206 McKenzie

May 27, 2025
PROPOSED:
STEEL CARPORT

Historic Review

RE: 206 McKenzie St.

1 NORTH - EXISTING
3/16" = 1'-0"

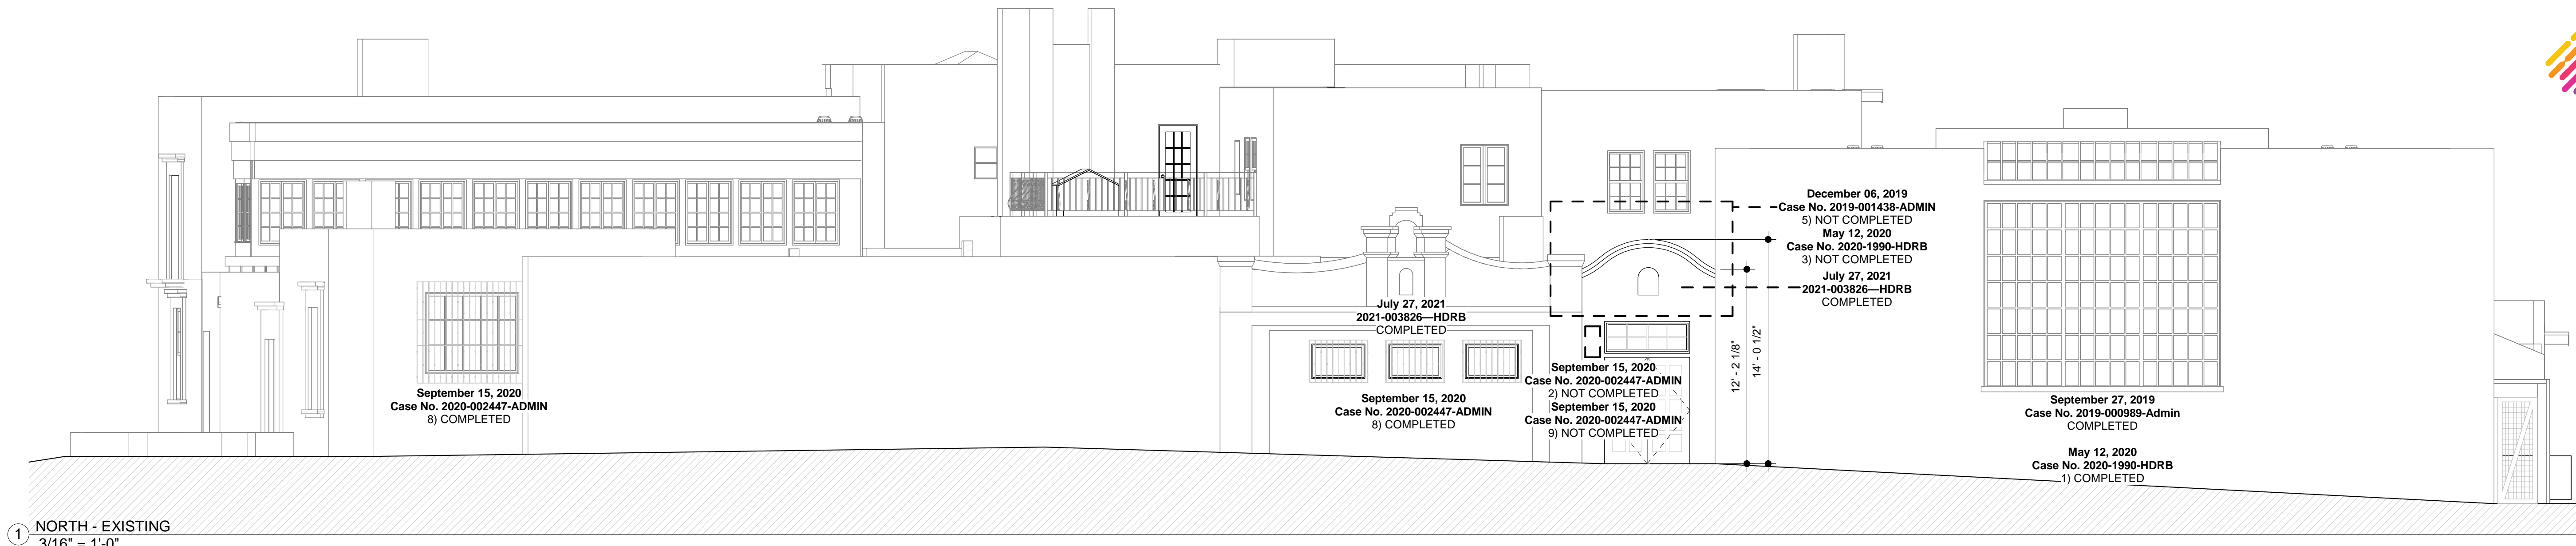
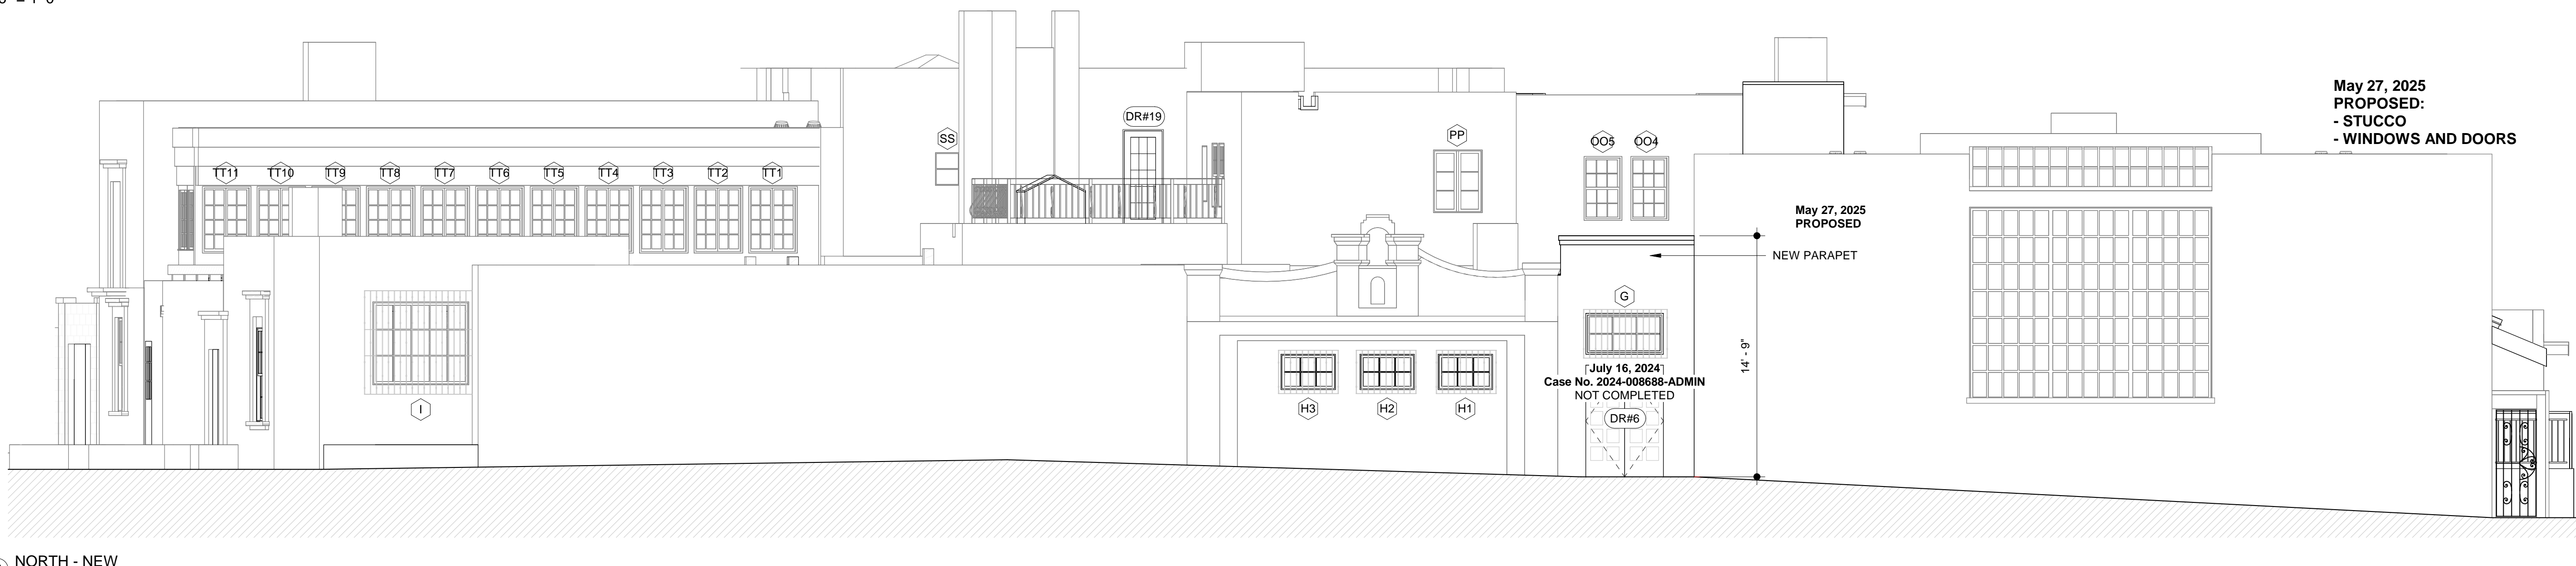
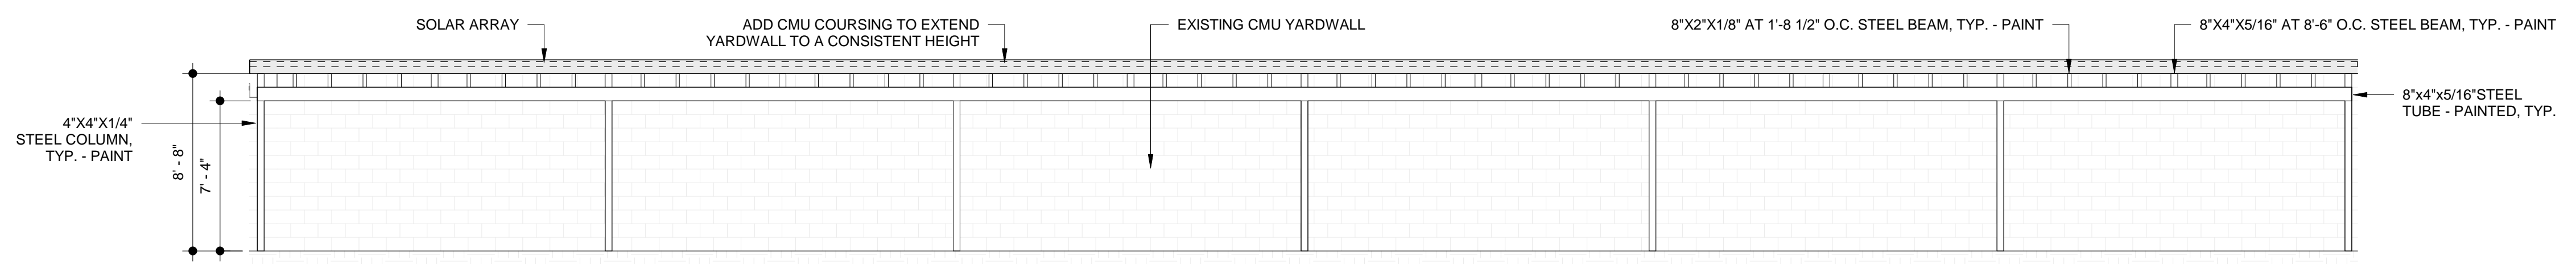
As requested by the Historic Review Board, we are proposing a revision to the design of the parapet extension which was presented at a previous meeting. The new design removes the arch located atop the wall and replaces it with a flat profile. Also removed from the new design is the small alcove similar to the existing one found on the adjacent façade. The new parapet design reduces the impact of the new wall on the north façade bringing it more in line with the aesthetic of the façade found to the west.
